CONTEMPLATED CHANGE ORDER

PROJECT	NAC ROOF REPAIRS PHASE 2	DATE	4/22/2021
CONTRACTOR	G&G ROOFING LTD.	CCO. NO.	6

Supplemental Instruction:

Nanaimo Aquatic Centre
Roof Parapet Repairs

Project Name	NAC PH 2 - Reroofing			Dwg. Ref.	R-2.1	
Sketch Title	SK01 - West Louver and Mechanical Mezzanine			Scale	N.T.S.	
				Date	2021/04/15	
				Project No.	NAN.101523.0006	
				Sketch Number	SK-01	Rev.
						00

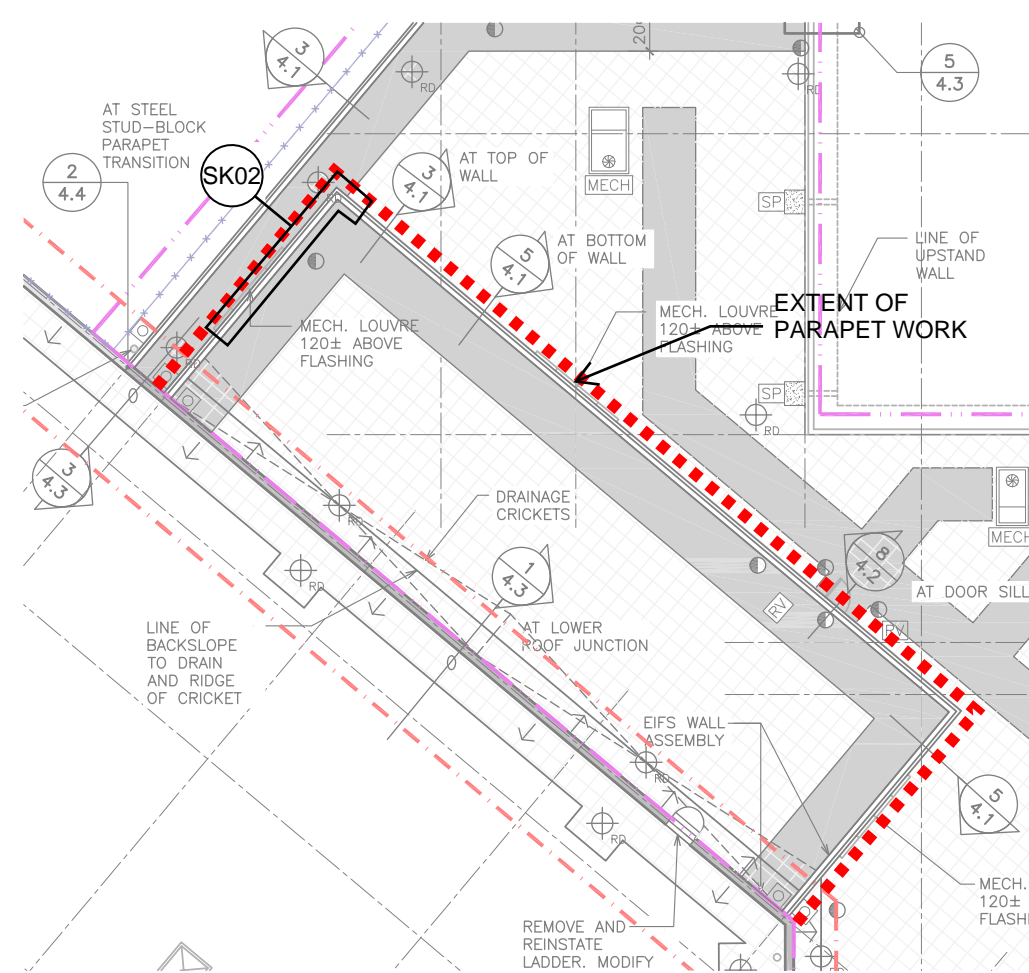
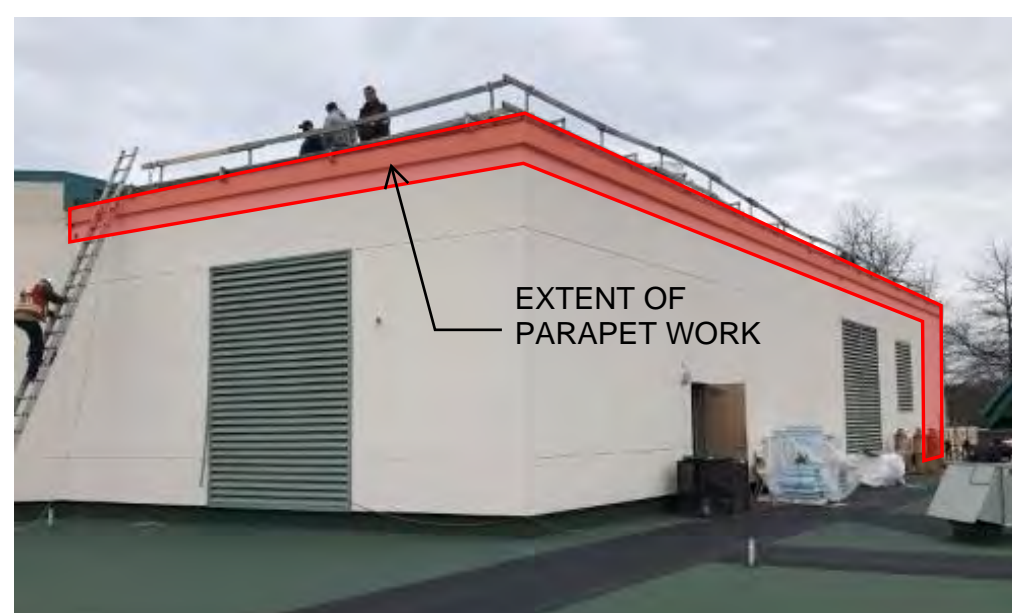
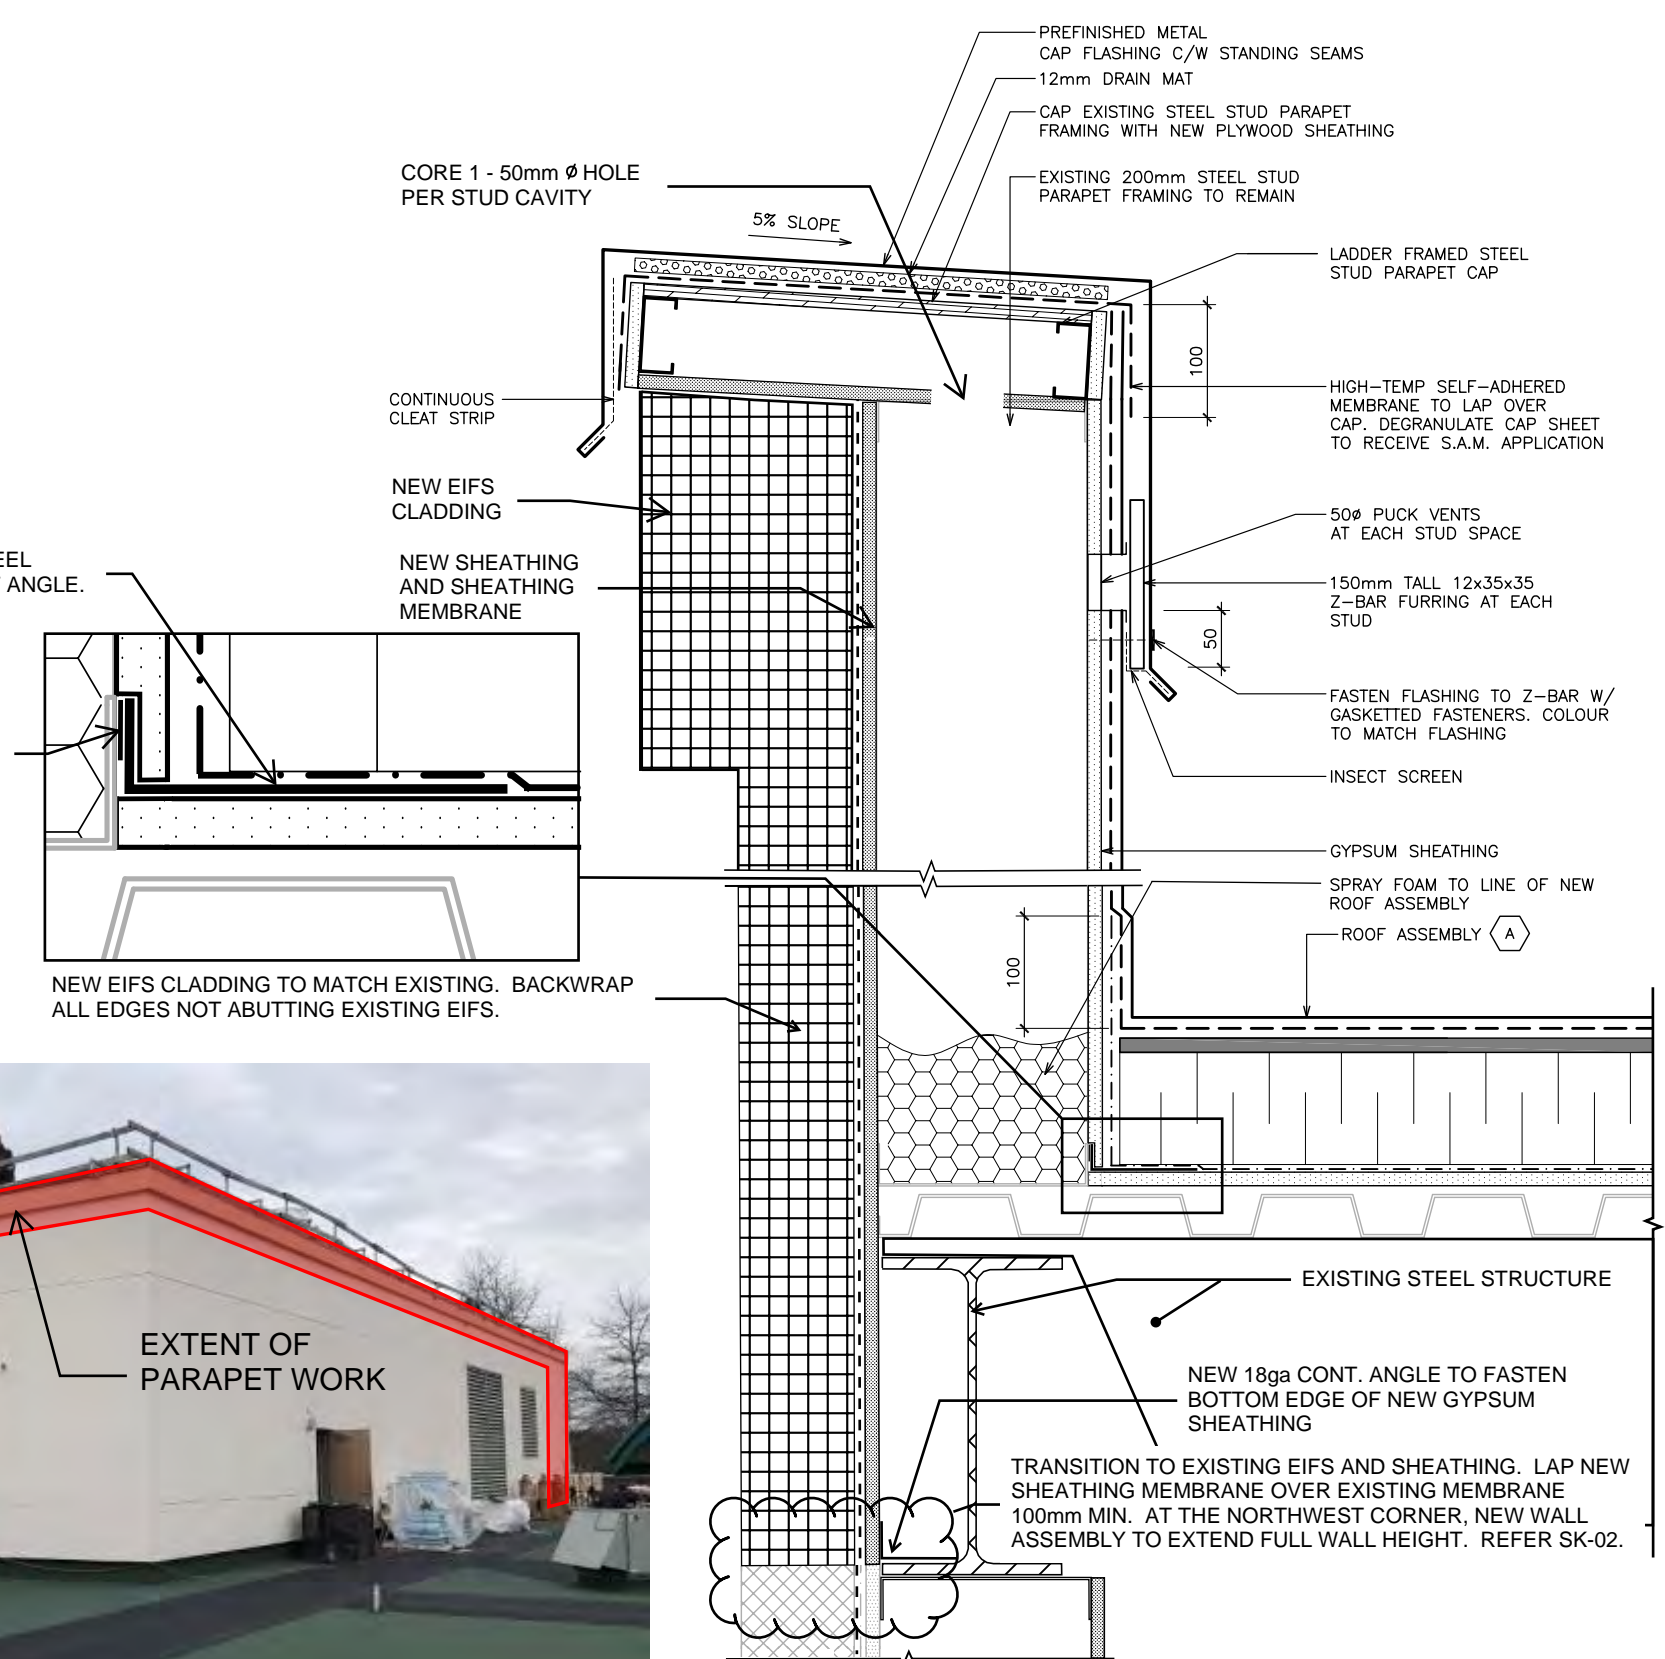
With reference to RJC SI 11 Rev: Various areas of the Mezzanine Mechanical room were found to have deteriorated due to the presence of moisture and the parapet and west wall around the louver require work additional to the original contract and as described in the attached SI (which supersedes the previously issued SI 11).

Note that SK-01, section 4 refers to Roof Assembly A. Please note that the existing gypsum sheeting is to be replaced with fibreglass-faced gypsum.

Replace the exterior cladding assembly, including sheathing, as indicated on the attached SK 01 - West Louver and Mechanical Mezzanine, SK 02 - West Louver and Mechanical Mezzanine. The area is to generally follow the depth of the parapet wall plus the depth of the I-beam below, with the exception of the west louver where the cladding assembly is to extend to the base of the Mechanical Mezzanine Wall as indicated in Detail 1 / SK 02 and around the corner a width of three stud cavities. Terminate vertical joints of sheathing on existing studs.

Existing paper-faced gypsum sheathing to be replaced with fibreglass-faced gypsum sheathing (Desglass Gold or approved equivalent). Replace existing sheathing membrane with new impermeable sheathing membrane (Henry Blueskin SA or approved equivalent).

New EIFS to match existing profile. Perimeter edges of the EIFS are to be backwrapped. Backwrapping does not apply where new EIFS abuts existing EIFS. Blend transition as evenly as reasonably possible.

In the southwest and southeast corners where the exterior face of the mechanical mezzanine parapet wall interfaces with the adjacent building wall, Contractor to retain 300mm of the existing mechanical mezzanine sheathing and membrane for tie-in purposes. Once exposed, Contractor to advise RJC if the retained sheathing is deteriorated.
